Zarzamora Pump Station Improvements Project  
SAWS Job No. 15-6101  
Solicitation No. CO-00144-DW

**ADDENDUM No. 2**

October 31, 2017

**SAN ANTONIO WATER SYSTEM**  
ZARCAMORA PUMP STATION  
IMPROVEMENTS PROJECT  
**YARD PIPING PLAN**

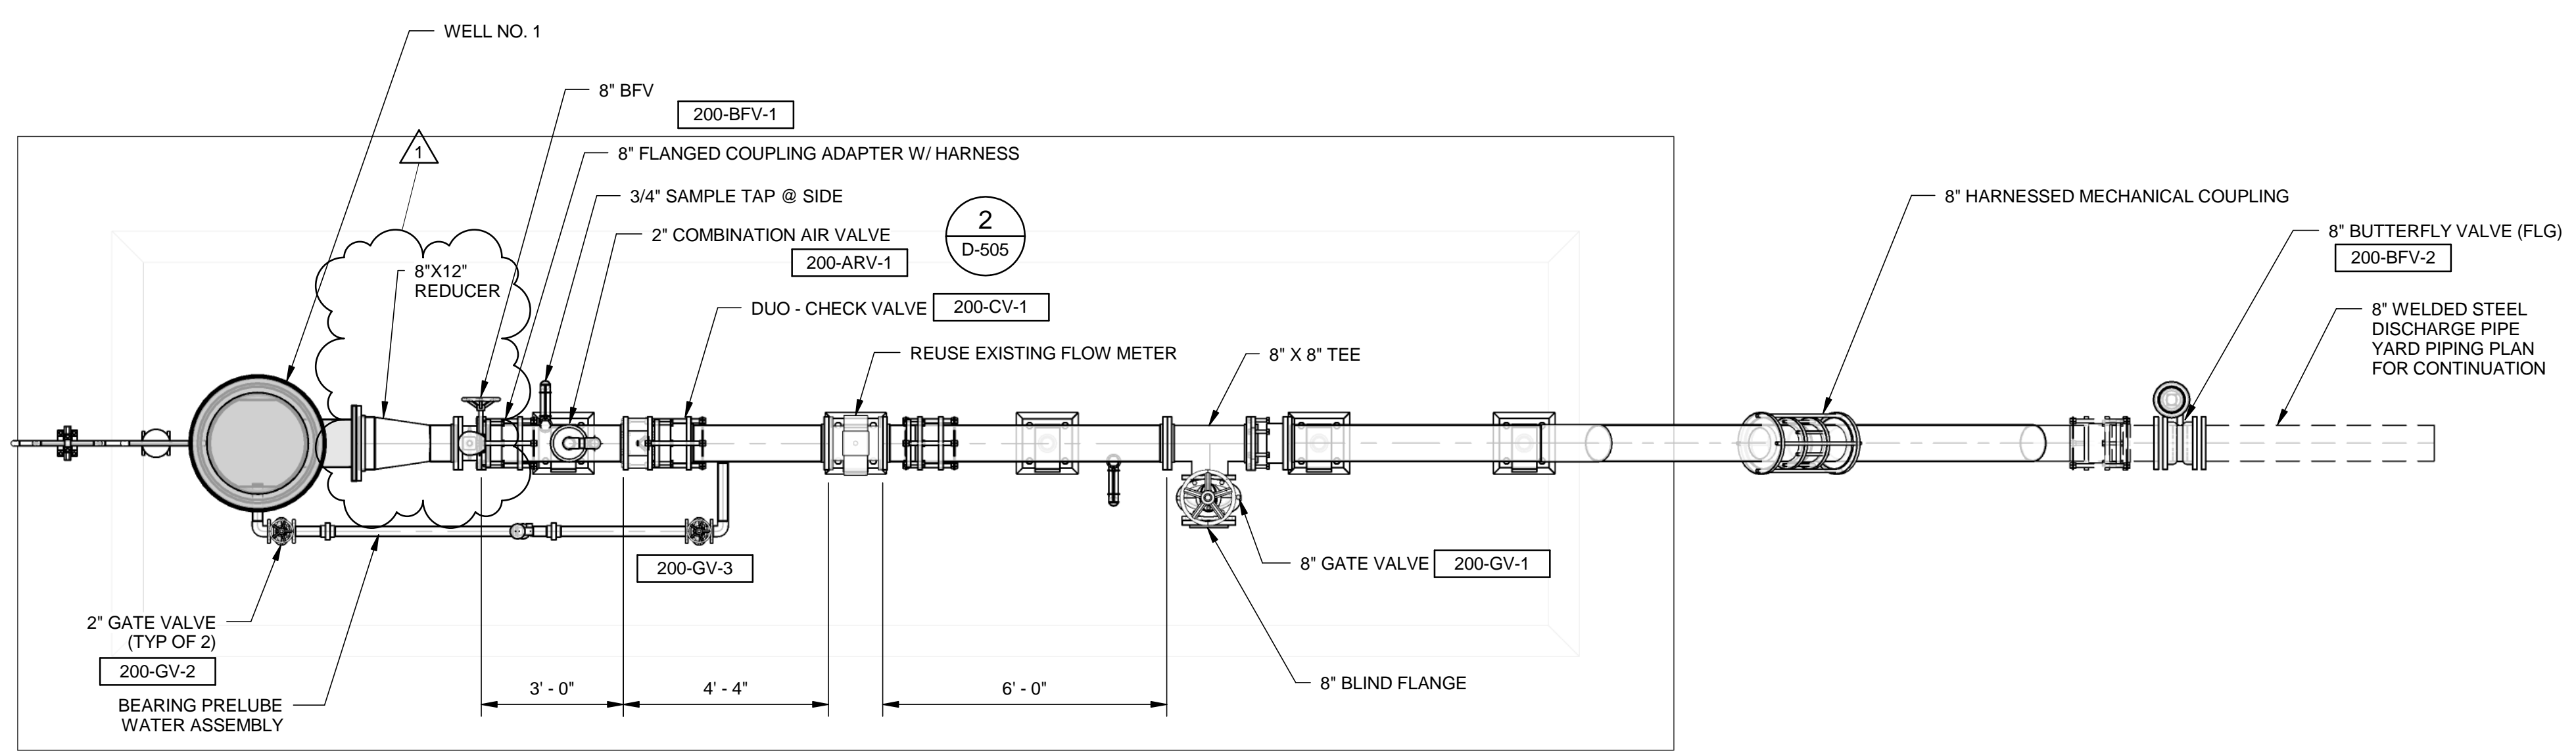
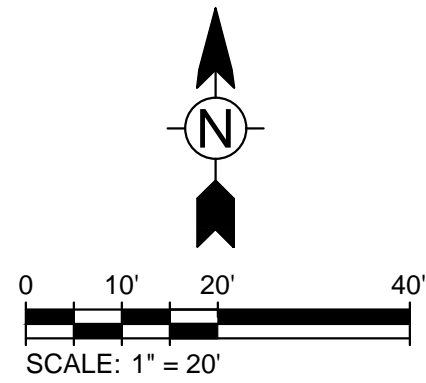
- 1.9.** In the plans for the Zarzamora Pump Station I've noticed a problem that requires addressing. On sheet C-107 Pipe A (lower left corner) is clearly labeled in many places as 24". On sheet D-203 all of the piping for Well #5 is indicated as 20". We didn't see any indication of a reducer anywhere. Is the piping for Well #5 20"? If it is 20" where the reducer should be placed?

**Response:** Revised sheets are included in No. 3.5 and No. 3.8 attached in this Addendum.
